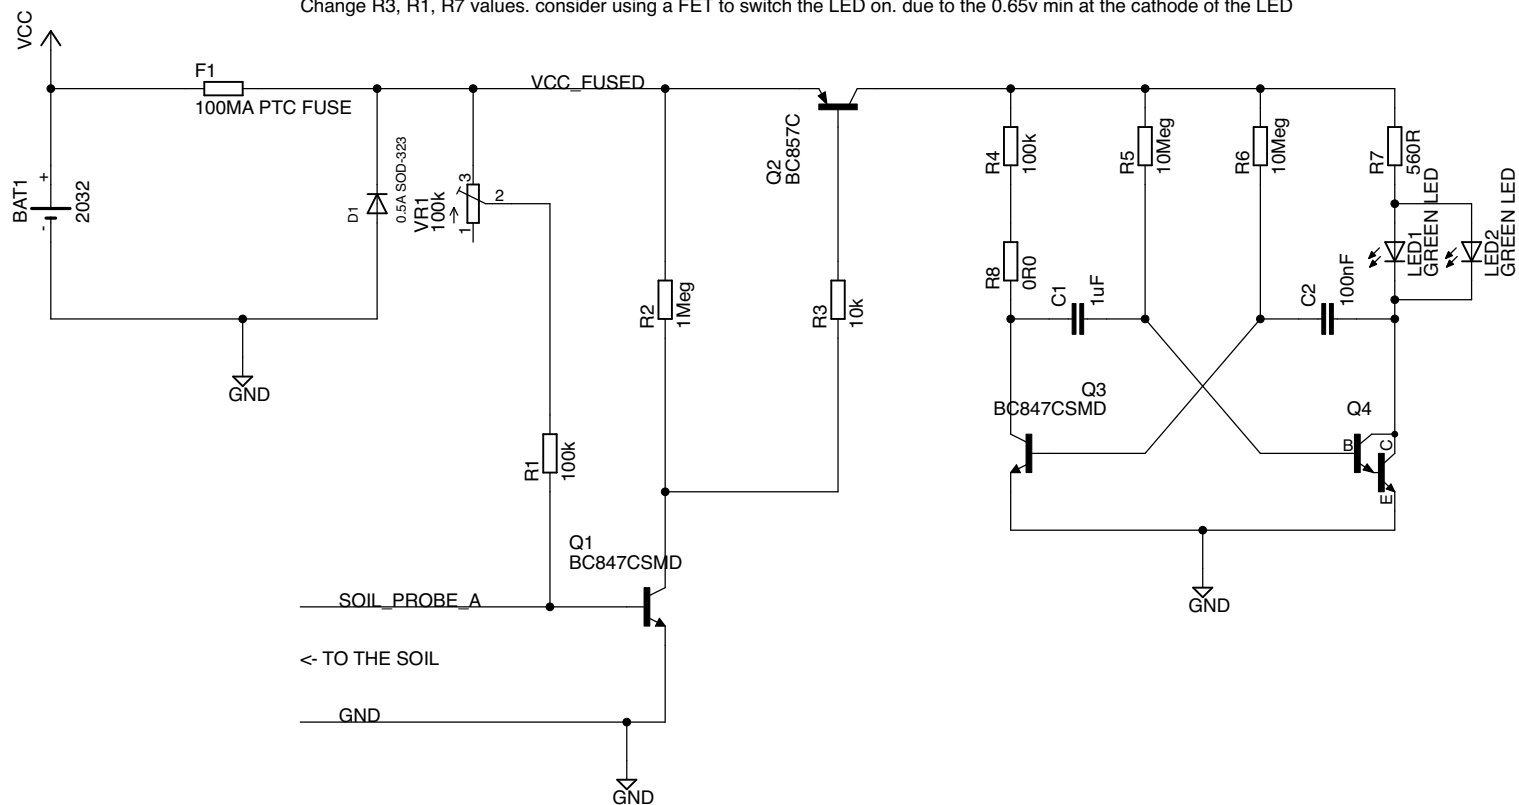
Change R3, R1, R7 values. consider using a FET to switch the LED on. due to the 0.65v min at the cathode of the LED
